June 25, 2024

**Re: Thunderbird Sand and Gravel, File No. M-2023-032,
Response to Adequacy Review No. 2**

THUNDERBIRD SAND AND GRAVEL
DRMS 112C PERMIT APPLICATION
PUEBLO COUNTY, COLORADO

SHEET:
EXHIBIT-C1

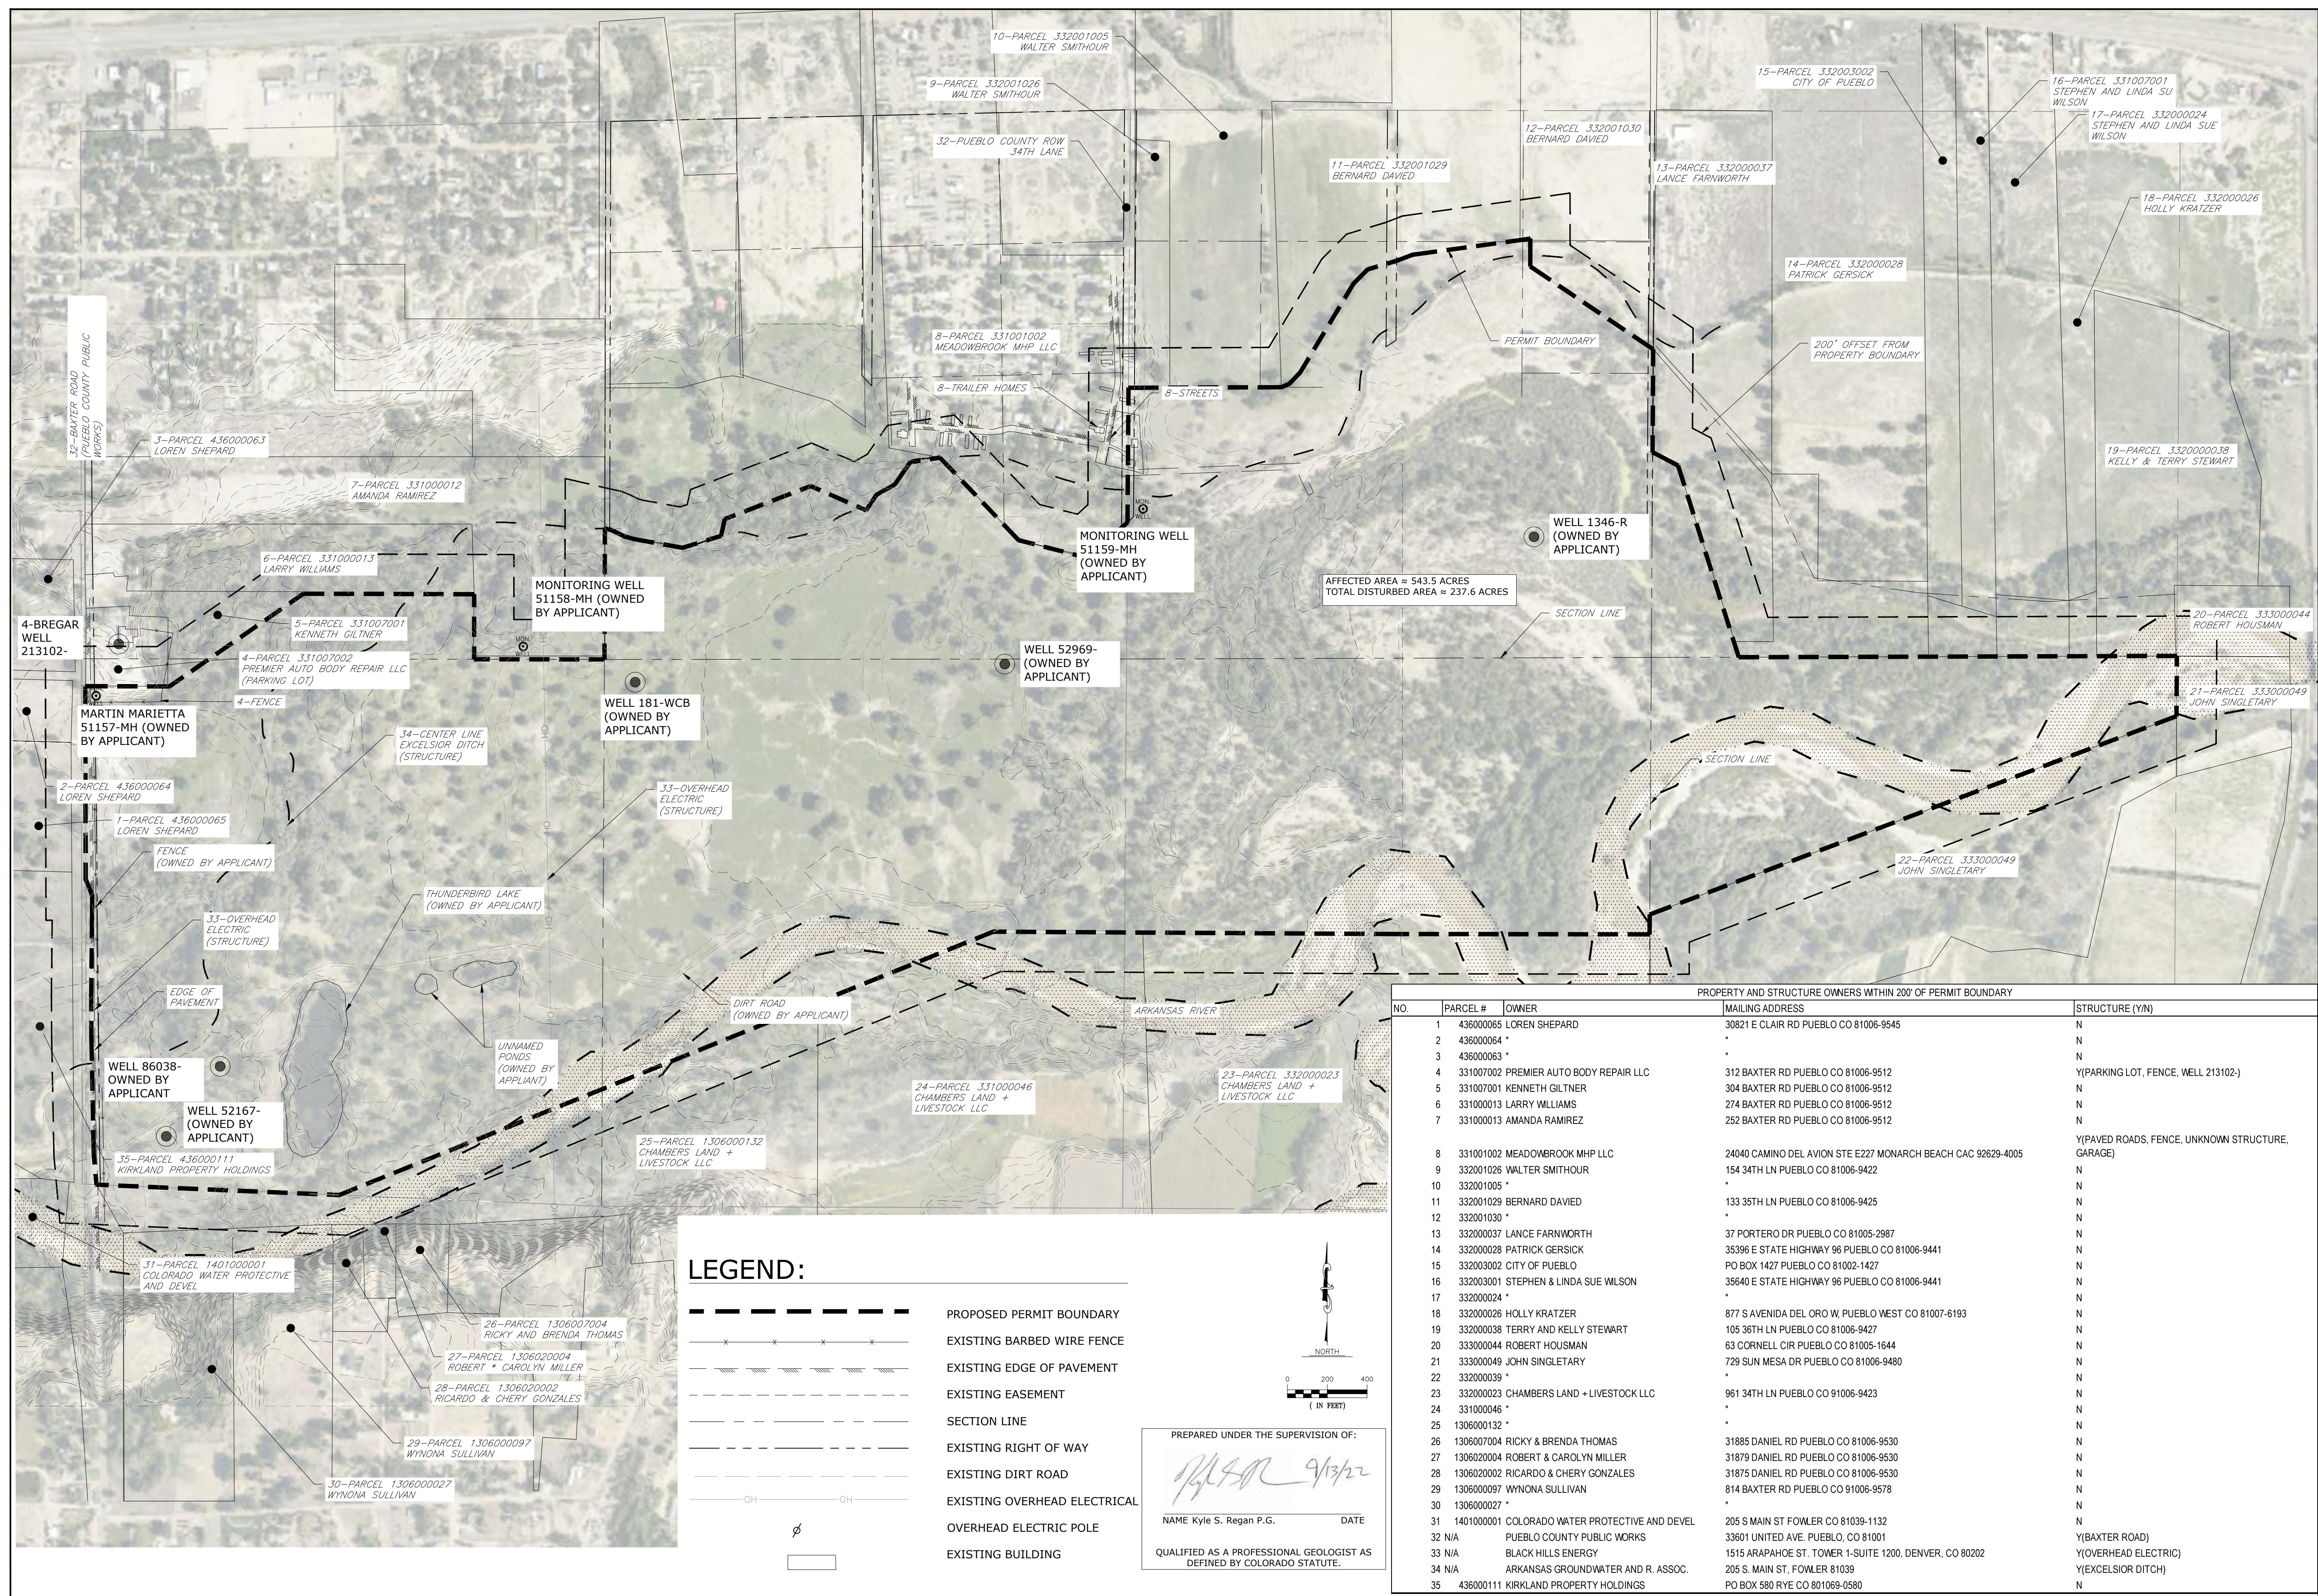
1. Exhibit C-1, C-2, and F-1 maps should clearly indicate the proposed permit boundary. The legend displays a thick dashed line to represent the permit boundary, but this line is not utilized on the maps.

Response: In the attached revised Exhibits C-1, C-2 and F-1, the dashed line in the legend and on the maps indicating the proposed permit boundary are now consistent.

SHEET:
EXHIBIT-C2

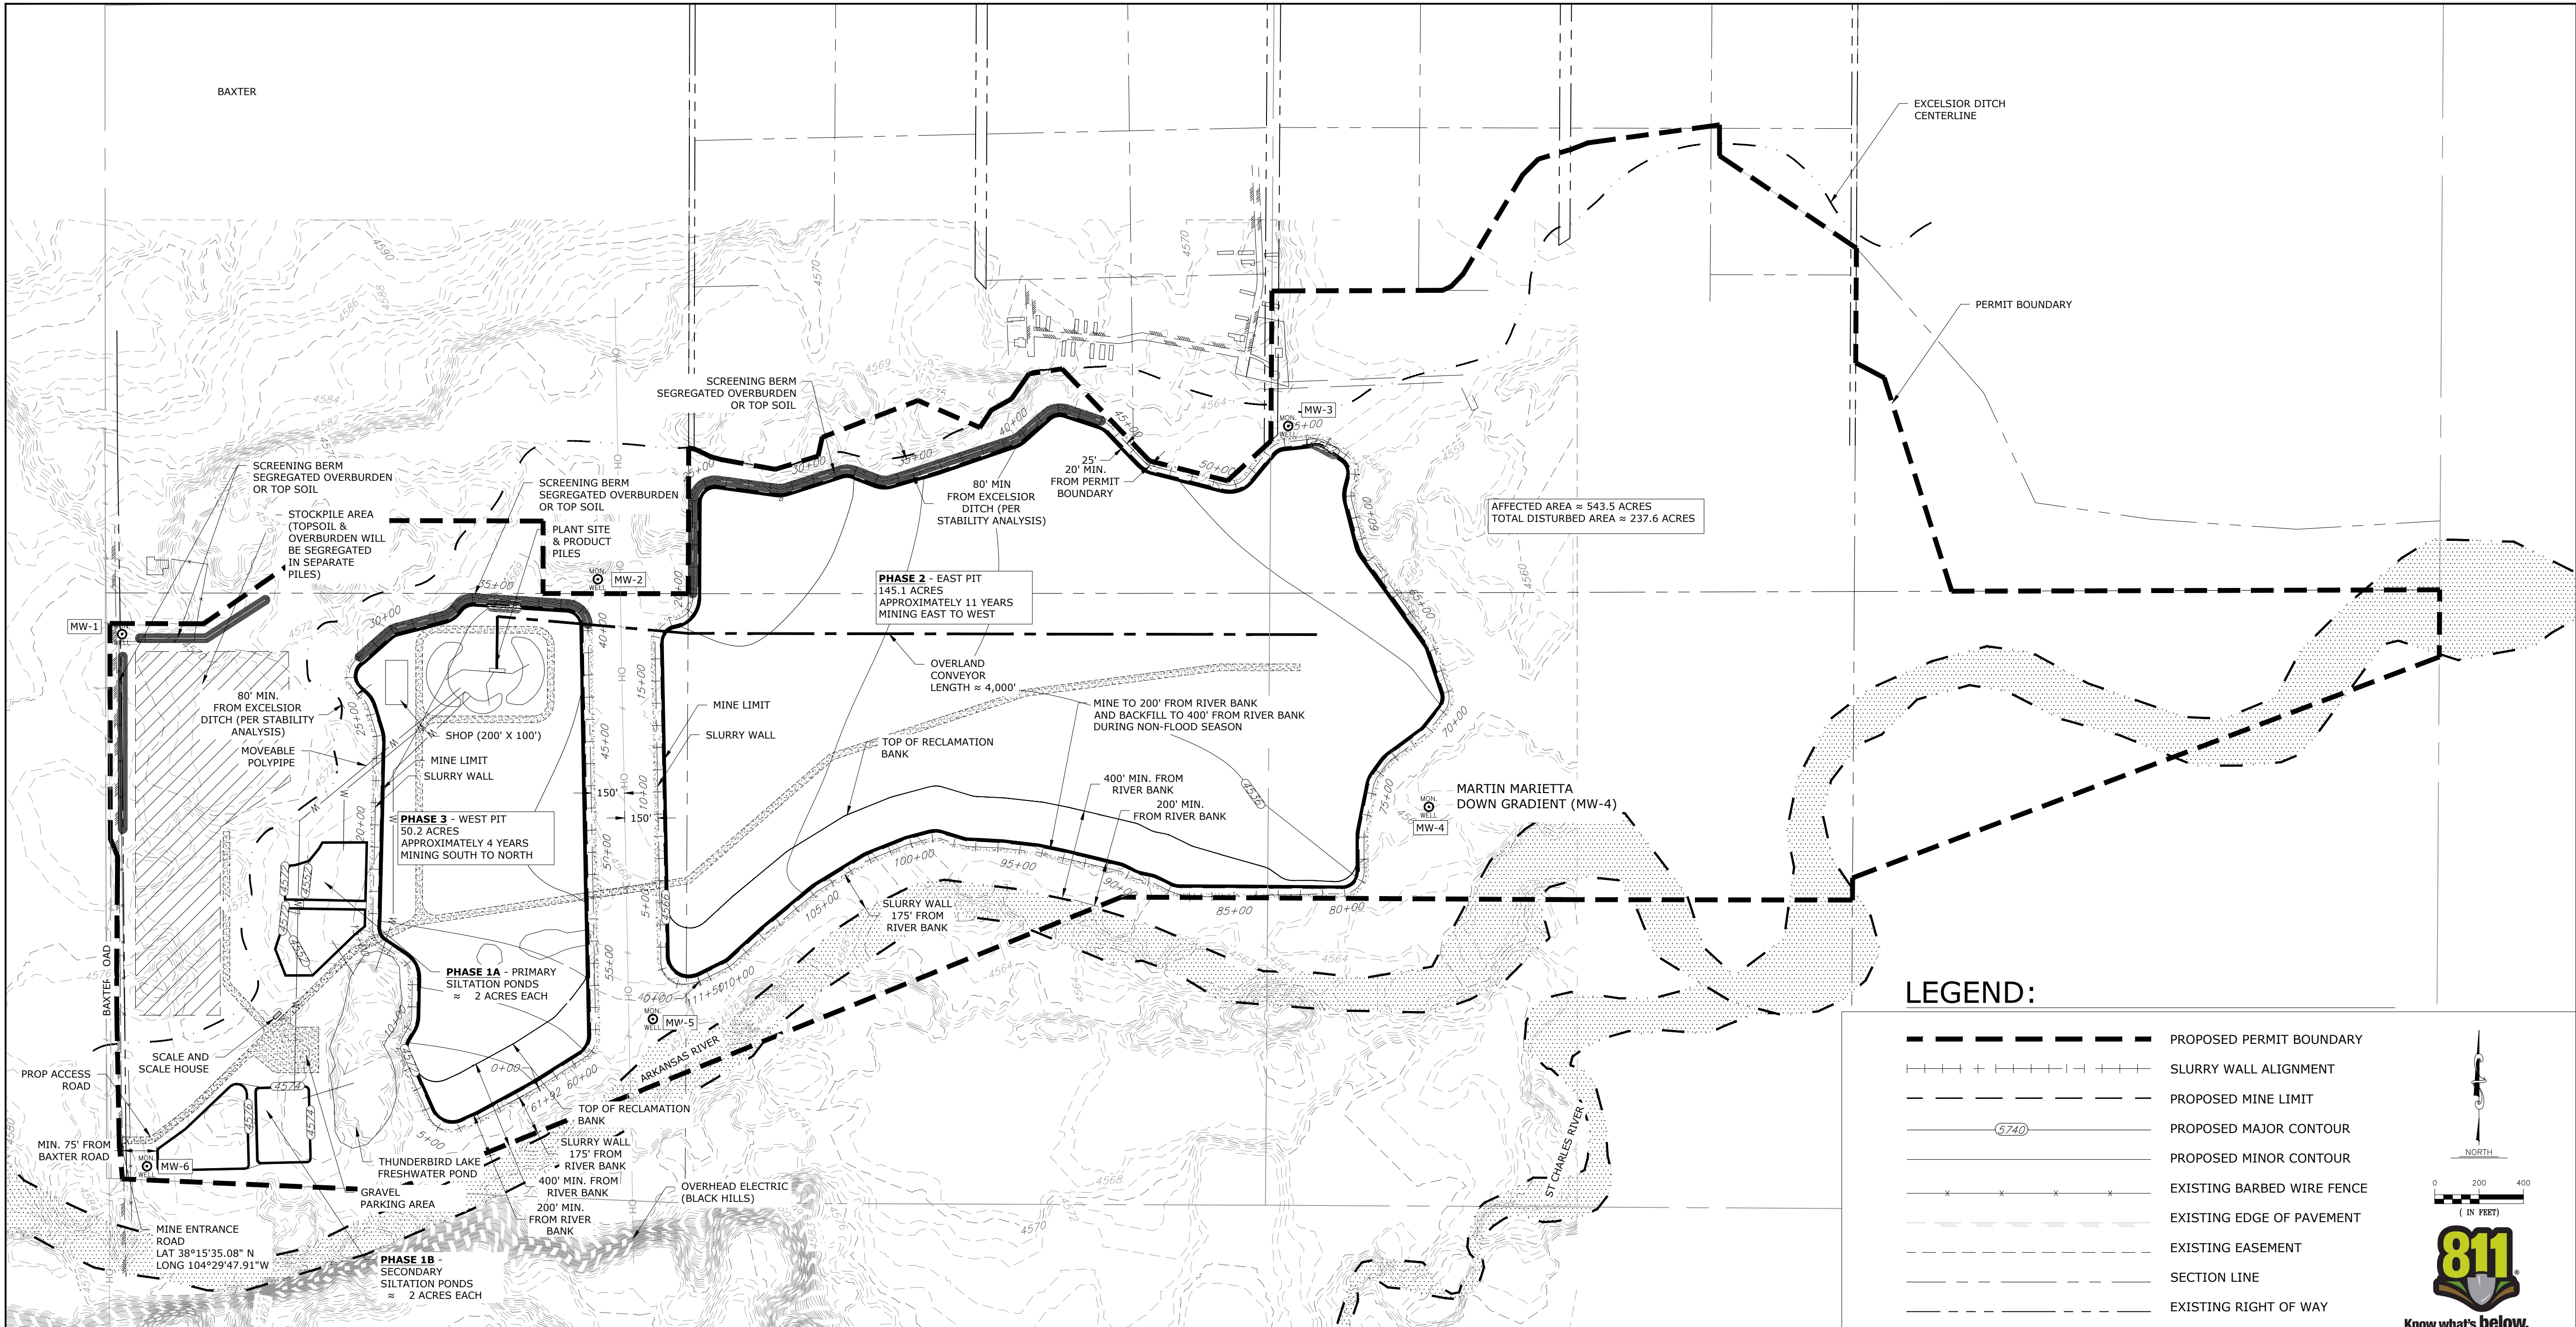
2. The map indicates screening berms as "Overburden or Topsoil," but stockpiles must be assigned as one or the other. Please designate separate overburden and topsoil stockpiles on the map.

3. Exhibit D under "Processing", describes pipelines that will move water from Thunderbird Lake to siltation ponds and back into Thunderbird Lake. The location of these pipelines need to be shown on the Mining Plan Map.

4. Please identify dewatering discharge points indicated in Exhibit G section (c) on to the Mining Plan Map.

5. Product stockpiles are proposed near the plant area within the proposed Phase 3 area. Is this the only location where the product will be stored?

6. Please indicate on the map where processing fines will be stored.

8. Please indicate the approximate location(s) of the “series of siltation ponds” proposed to occur within the processing area per Exhibit D.

20. Please clarify the planned use of the proposed stockpile area located north of the Excelsior Ditch. According to the Exhibit C-2 map, this area will only be used for “topsoil and overburden”. Will this area also be used for product stockpiles? Please update the Exhibit C-2 map accordingly.

Response: Overburden and topsoil are now designated on the attached revised Exhibit C-2 Map.

Response: Approximate pipeline locations are shown on the revised Exhibit C-2. It is anticipated that the location of these pipelines will change as mining and siltation operations change during the life

of the mine. It should be noted the pipelines used are typically temporary HDPE pipe that is easily moved and will be removed upon completion of mining.

Response: Approximate discharge points are shown on the revised Exhibit C-2.

Response: In addition to the Phase 3 area, product stockpiles may be stored in mined areas of Phase 2 and in the northwest area (north of the Excelsior Ditch), as shown on the revised Exhibit C-2

Response: The siltation ponds are located in Phases 1a and 1b as shown on Exhibit C-2.

Response: See response #5 above. The Exhibit C-2 map is updated.

SHEET:
EXHIBIT-F1

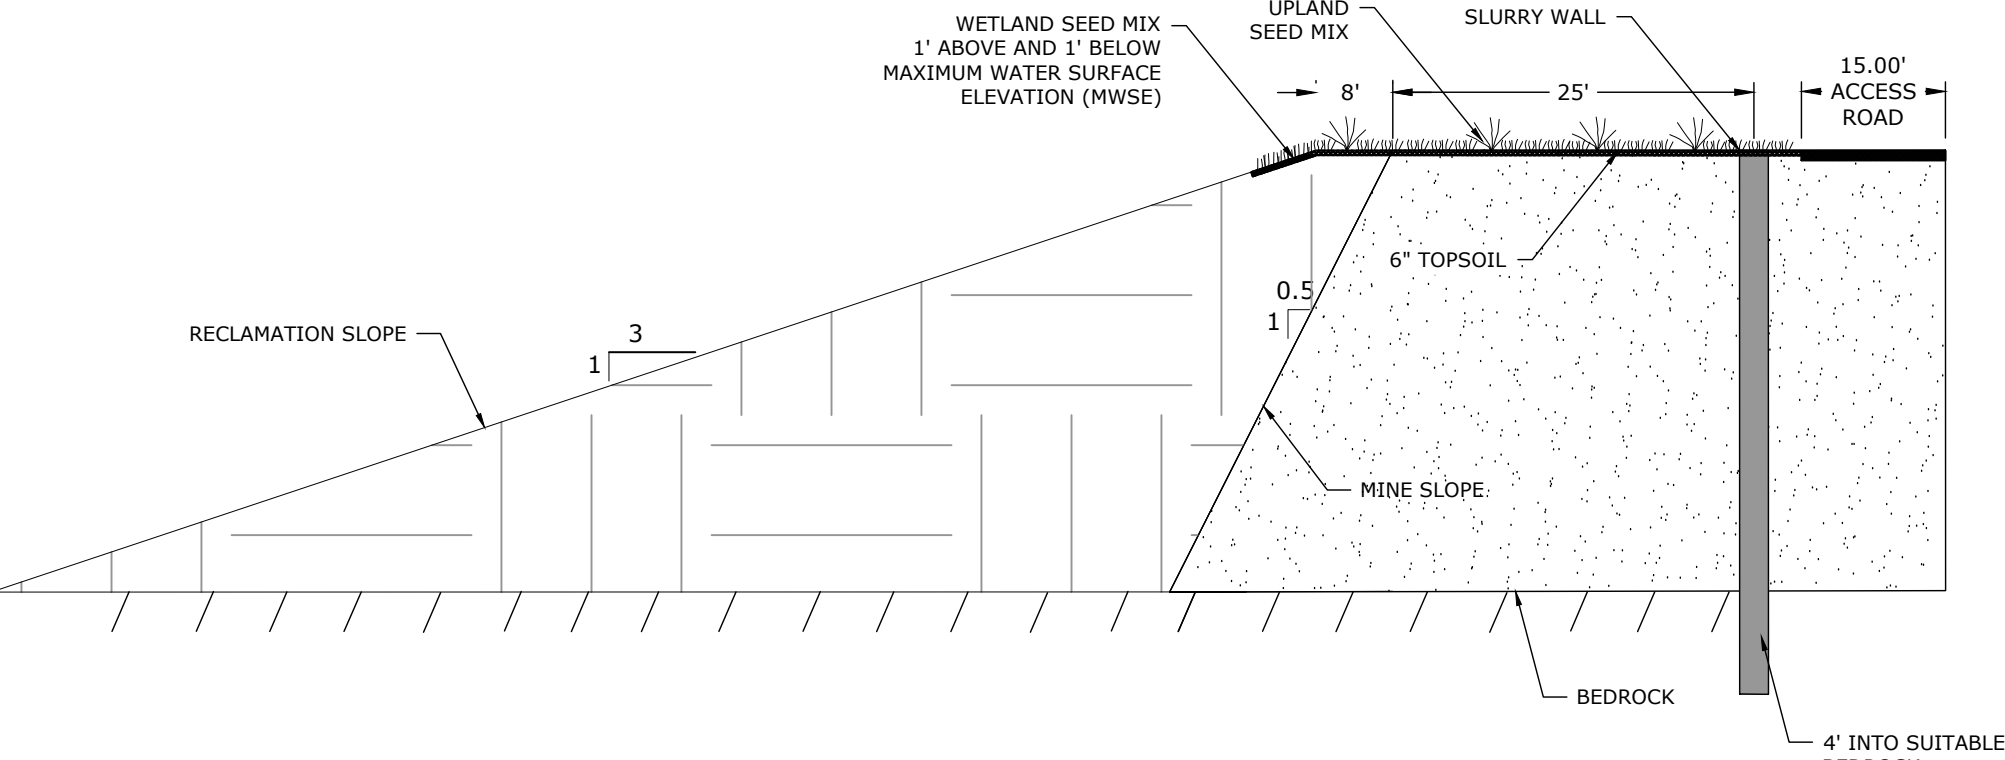
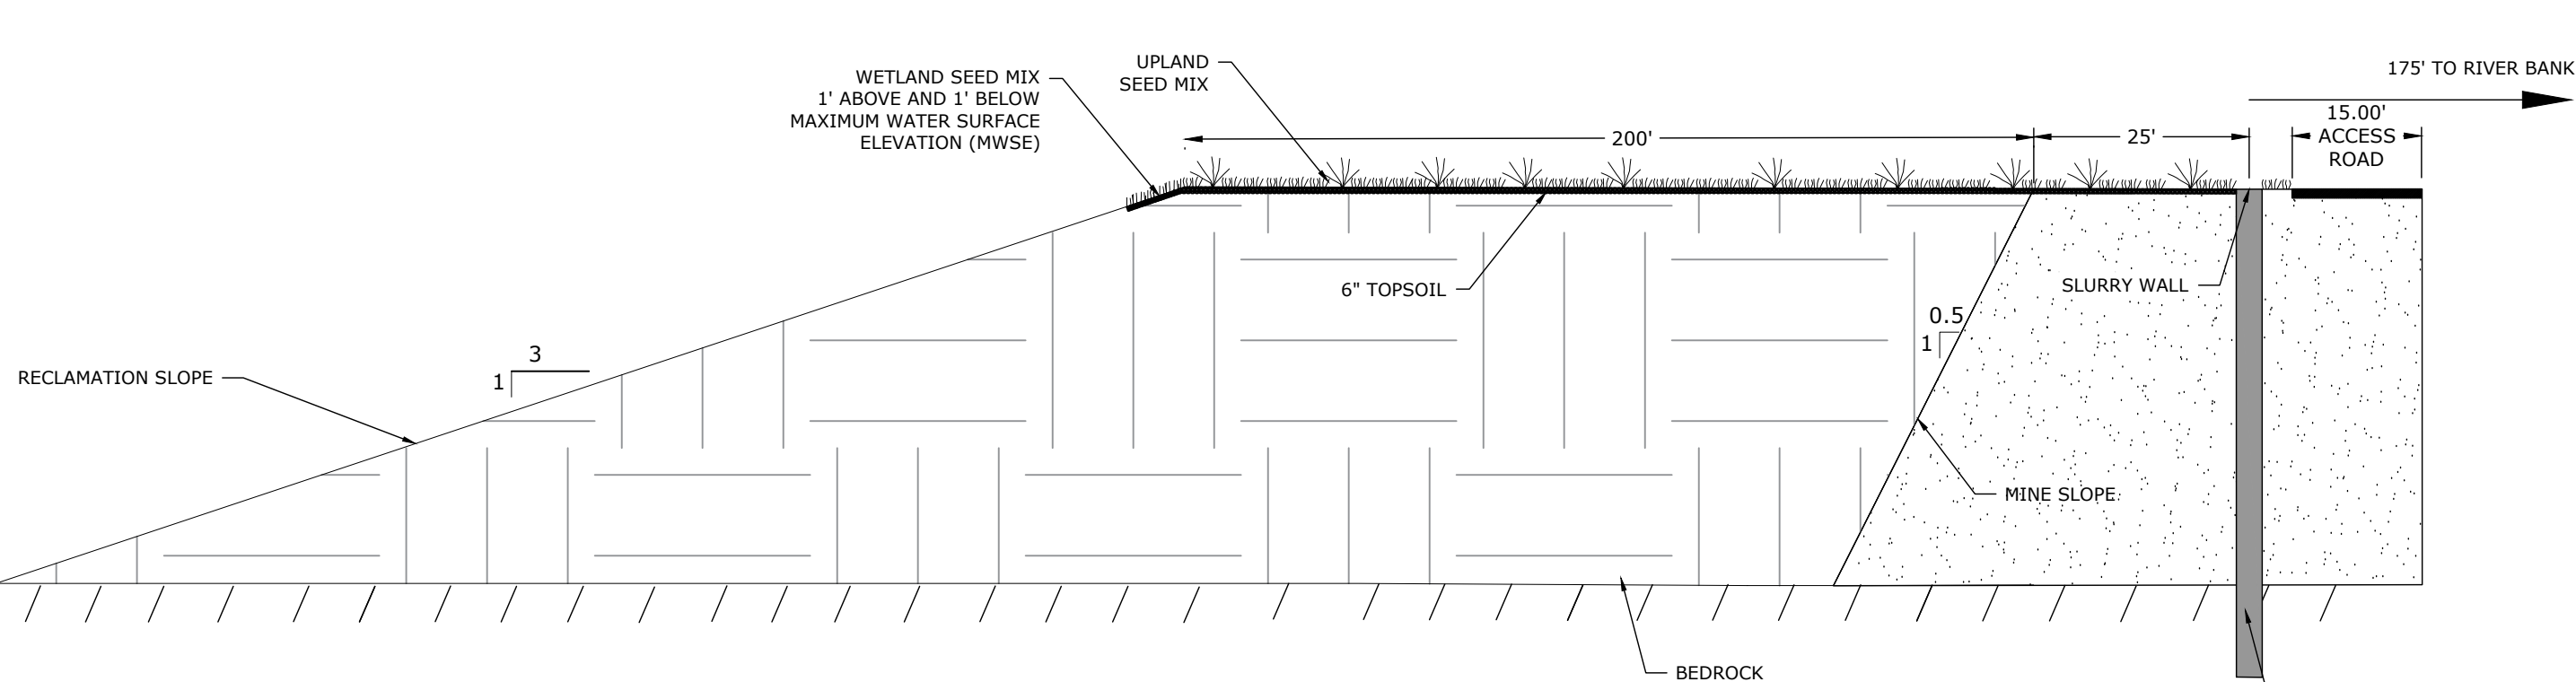
33. The applicant is proposing to use two separate seed mixtures for revegetation, including an upland seed mixture and a wetland seed mixture. Please provide an estimated total acreage that will be seeded with each mixture.

Response: Acreages for each seeding type are included in revised Exhibit L and shown on revised Exhibit F.
